**DOCUMENT 00 90 00
ADDENDUM**

ADDENDUM NO. [2] M Date: April 4, 2018

**RE: WITC – SUPERIOR CAMPUS
SUPERIOR INTERIOR AND EXTERIOR MAINTENANCE & REMODEL
600 N 21ST STREET
SUPERIOR, WI 54880
HSR PROJECT NO. 17063-1**

FROM: HSR Associates, Inc
100 Milwaukee Street
La Crosse, WI 54603
(608) 784-1830

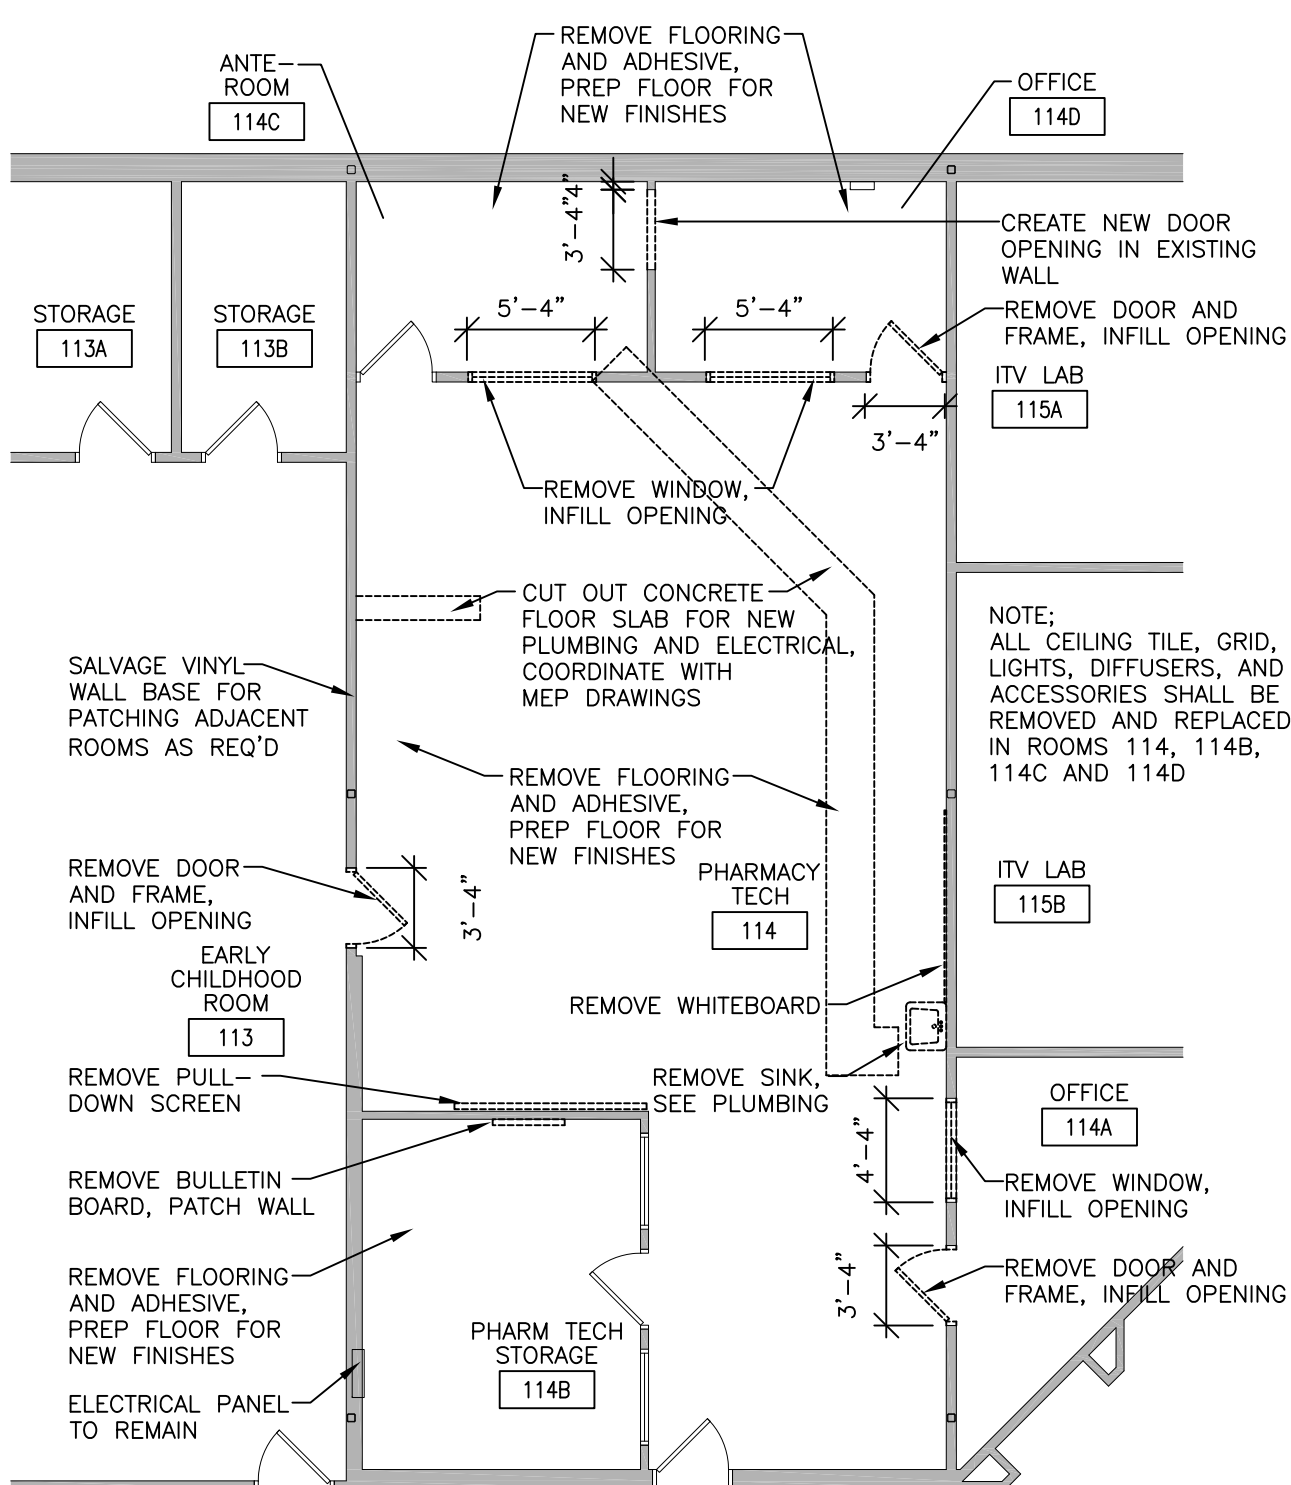
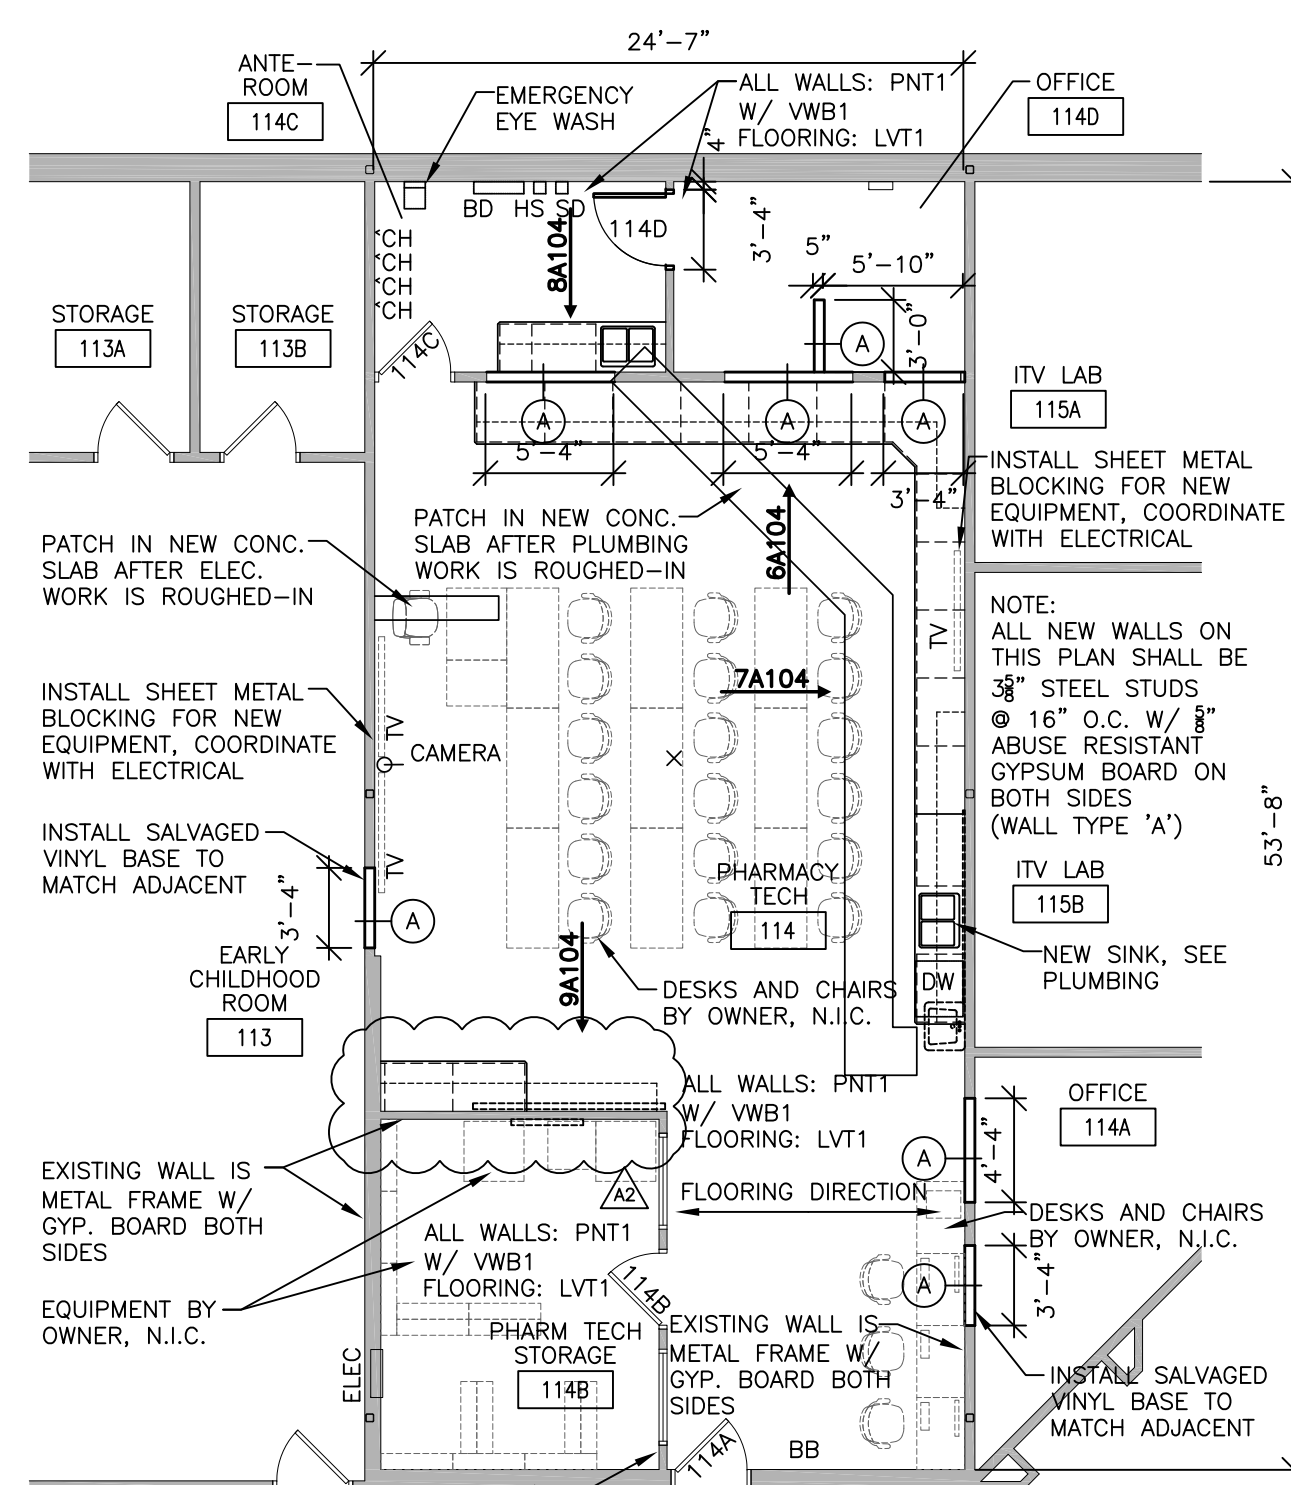
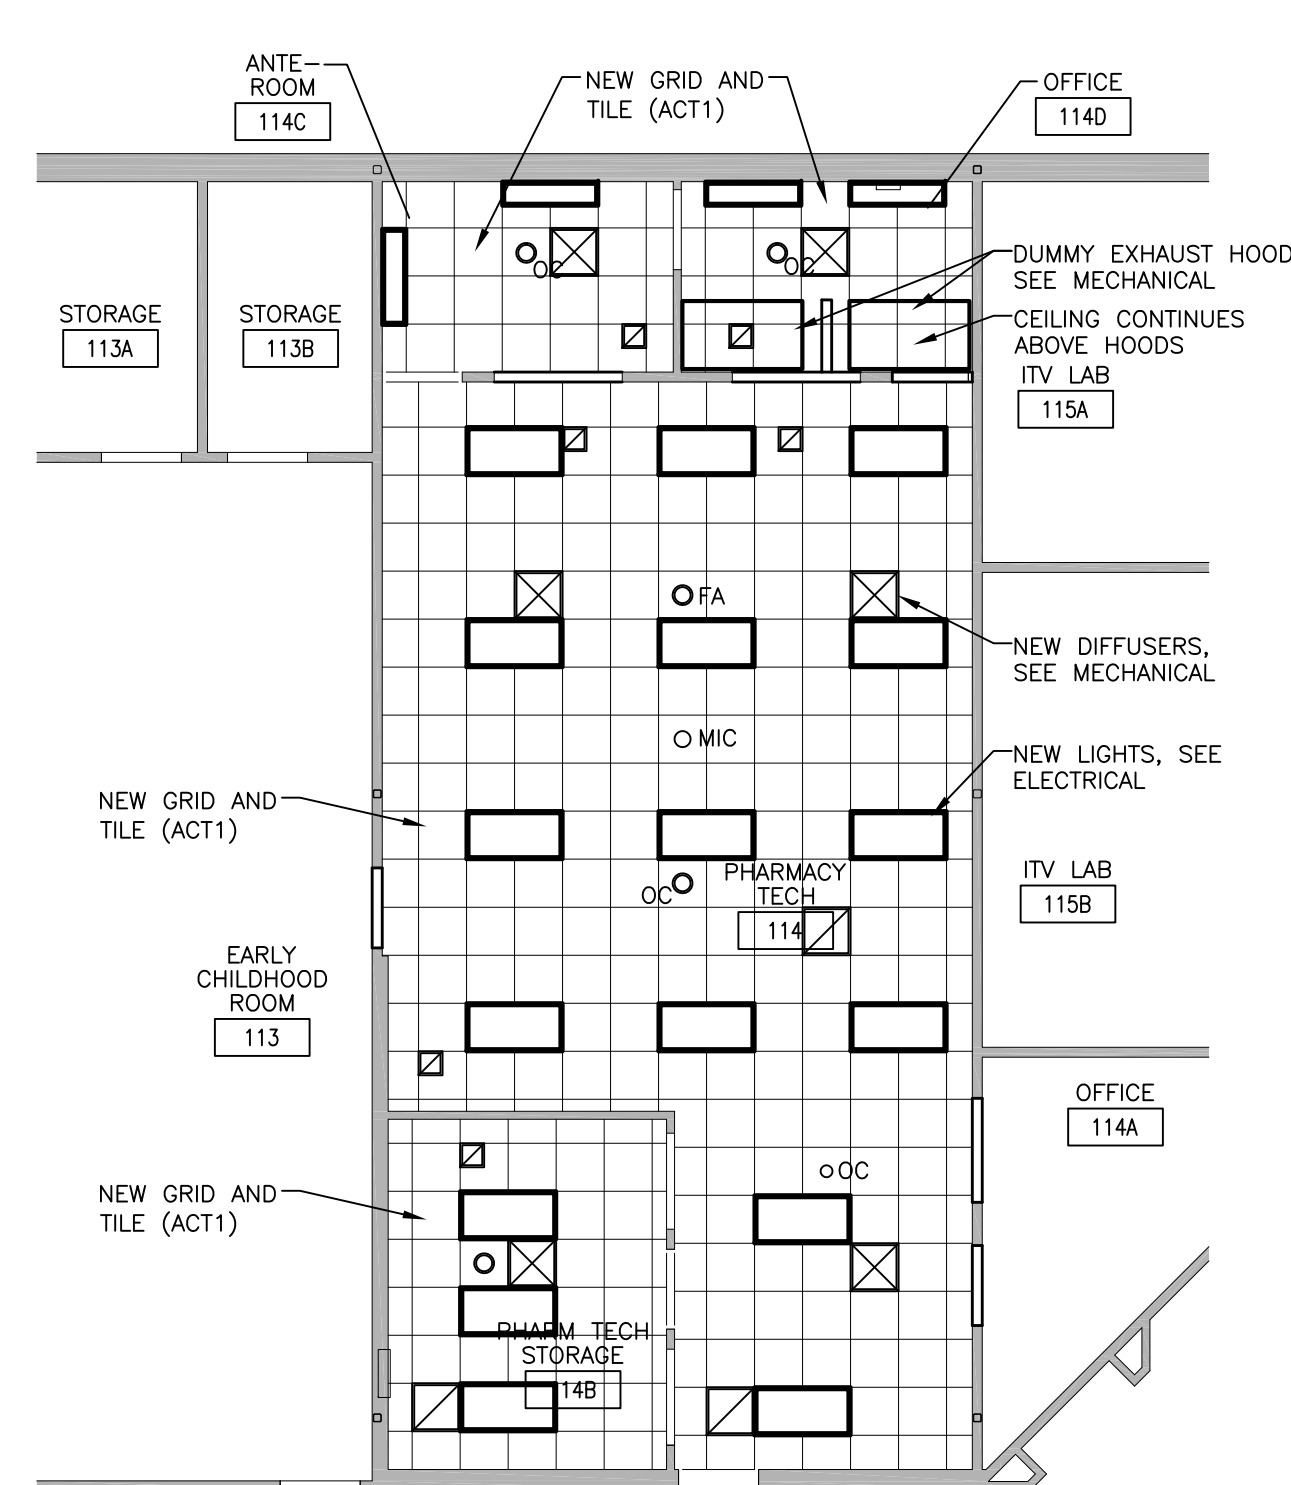
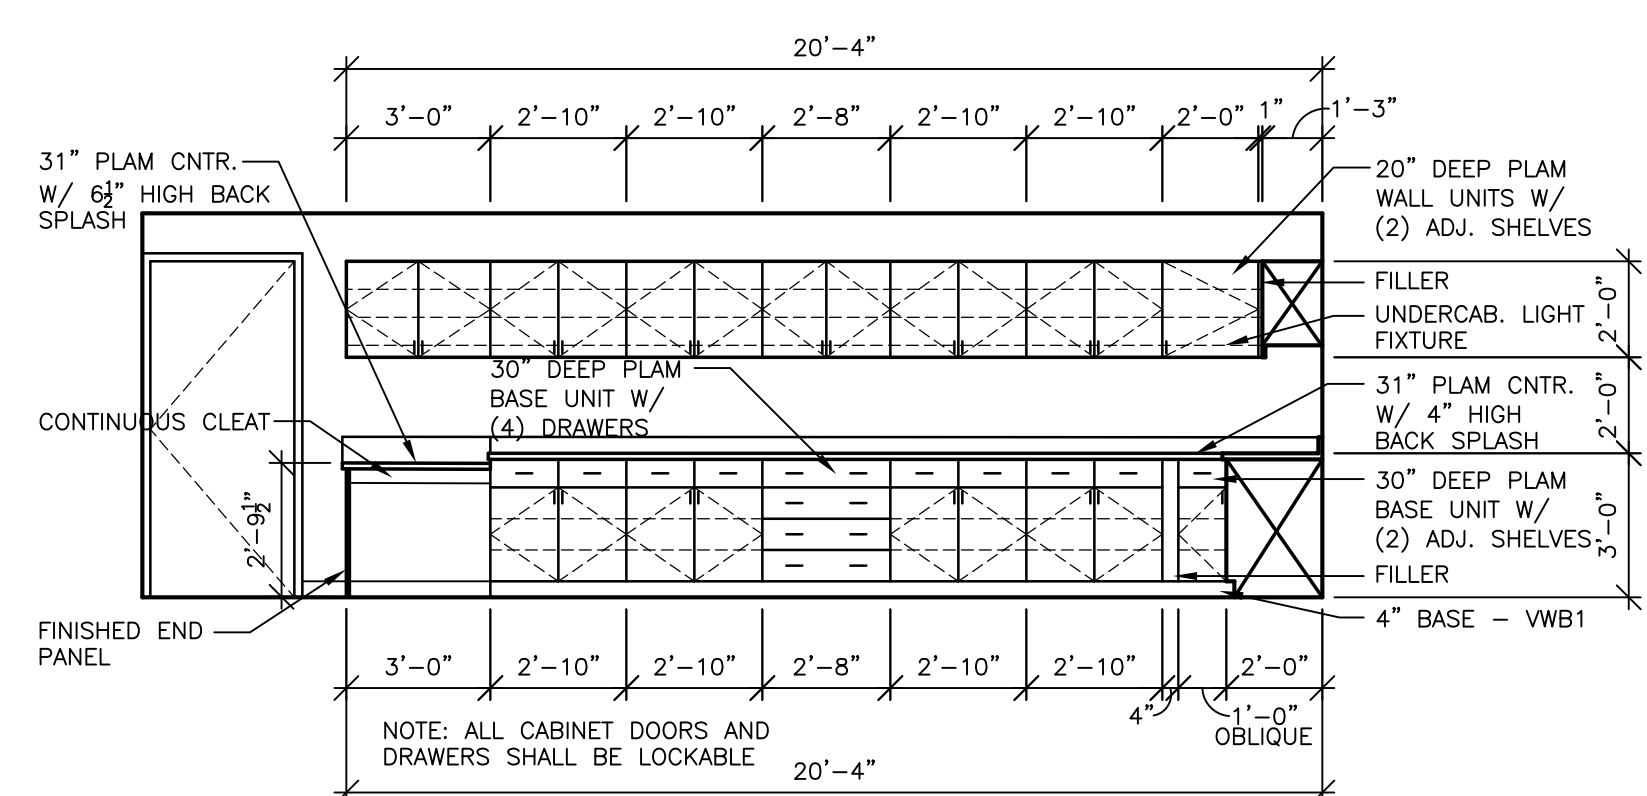
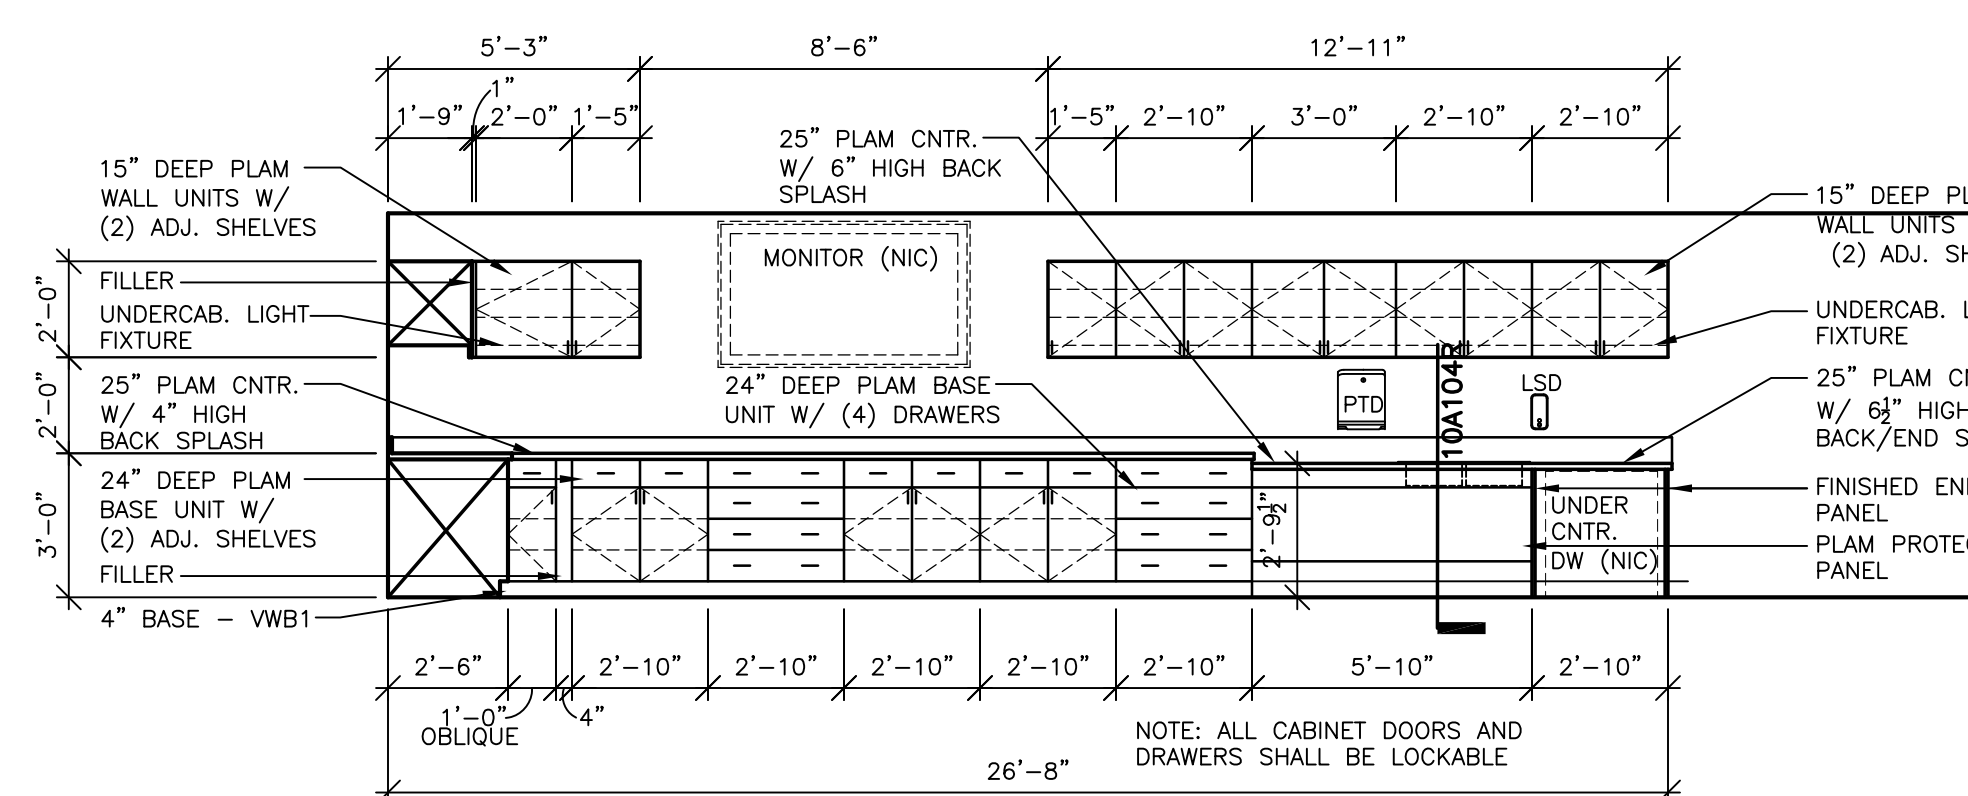
- a. Revisions clouded on Drawing.
11. Sheet A104R1 PHARMACY TECH PLANS AND DETAILS 30 x 42 attached hereto
 - a. Revisions clouded on Drawing.
12. Sheet A310R PLAZA SECTION, ELEVATIONS AND DETAILS 30 x 42 attached hereto

ALL DETAILS HAVE BEEN REVISED.
